Access Compliance Report

Public Rights-of-Way

(Curb Ramps)

Intersection ID: 31904	Main Street: CHAPECLANE_RD	Cross Street: PALOMAR_MOUNTAIN_DR	Location: NW
ADA ID: D27C298636D6	Ramp Type: PerpDiag	Initial Pass/Fail: Fail	Overall Compliance: No
Severity Score: 10			
Codes/Mitigation Info/Possible Solution		Field Measurements/Component Compliance

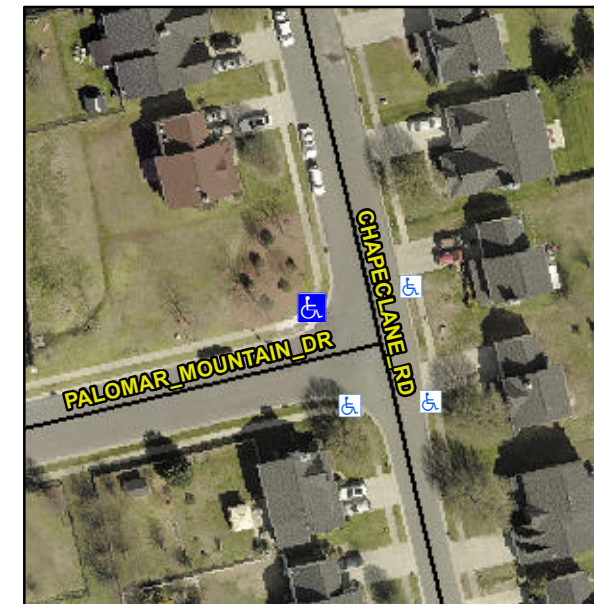
Not Found, R304.5.1, R304.5.3

Compliance	Description	Data	Compliance	Description	Data
N/A	Ramp Length (in)	48.0	Yes	Ramp Slope (%)	5.1
No	Ramp Width (in)	42.5	No	Ramp XSlope (%)	2.4
N/A	Flare Type LT	N/A	N/A	Flare Type RT	N/A
N/A	Flare Slope LT (%)	N/A	N/A	Flare Slope RT (%)	N/A
N/A	Flare Traversable LT?	N/A	N/A	Flare Traversable RT?	N/A
N/A	Landing Length (in)	N/A	N/A	DWS Provided?	N/A
N/A	Landing Width (in)	N/A	N/A	DWS Contrast?	N/A
N/A	Landing Slope (%)	N/A	N/A	DWS Length (in)	N/A
N/A	Landing X Slope (%)	N/A	N/A	DWS Full Width?	N/A
N/A	Landing Curb? (Y/N)	N/A	N/A	DWS Offset (in)	N/A
N/A	Shared Landing?	N/A			
N/A	Gutter Ponding?	N/A	N/A	Gutter Slope (%)	N/A
N/A	Gutter Lip Ht (in)	N/A	N/A	Gutter X Slope (%)	N/A
N/A	Painted X Walk1?	No	N/A	Painted X Walk2?	No
	X Walk 1 Direction	To S		X Walk 2 Direction	To E
N/A	X Walk 1 Width (in)	N/A	N/A	X Walk 2 Width (in)	N/A
	X Walk 1 Slope (%)	2.3		X Walk 2 Slope (%)	2.6
	X Walk 1 X Slope (%)	0.3		X Walk 2 X Slope (%)	0.3

Remove & Replace Curb Ramp With Two New Directional Ramps or Equivalent.
